Please find our comments on the draft Little Spokane River DO, pH and Phosphorus TMDL. Our comments are attached as a PDF Doc. Spokane Riverkeeper

RE: Little Spokane River Dissolved Oxygen, pH, and Total Phosphorus Total Maximum Daily Load Water Quality Improvement Report and Implementation Plan - Publication Number 20-10-033

Roadside shoulder in the LSR Basin - **Spokane County**

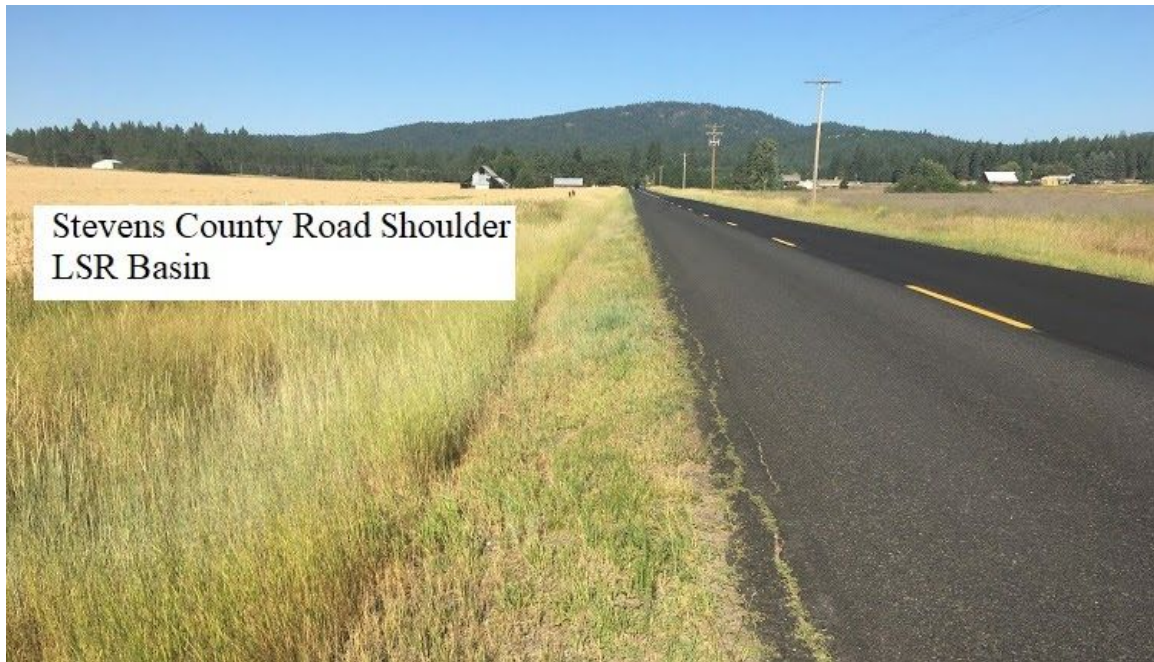
Page 58: SRK recommends WSDOT/Spokane County Action steps in the TMDL. The draft TMDL has lots of prescriptive BMPs for private agriculture but is missing strong, concrete, prescriptive actions and BMPs to intercept stormwater from the vast network of public roads that are under the jurisdiction of Spokane County and WSDOT. Again we urge to see the condition of county roads in the Little Spokane River Basin and understand the urgent need to deal with this persistent and pernicious source of pollution.

SRK recommends mandating the aggressive phase-out of stormwater conveyances, and outfalls to the tributaries and the LSR. Specifically, bullet #5 on this page should have concrete and specific, prescriptive actions and BMPs - such as Low Impact Development - that are listed out and described. These should include benchmarks and timetables that are agreed to between WDOE, WSDOT, and Spokane County to bring the MS4 outfalls and simple roadside ditches into compliance with TMDL planning and water quality attainment.
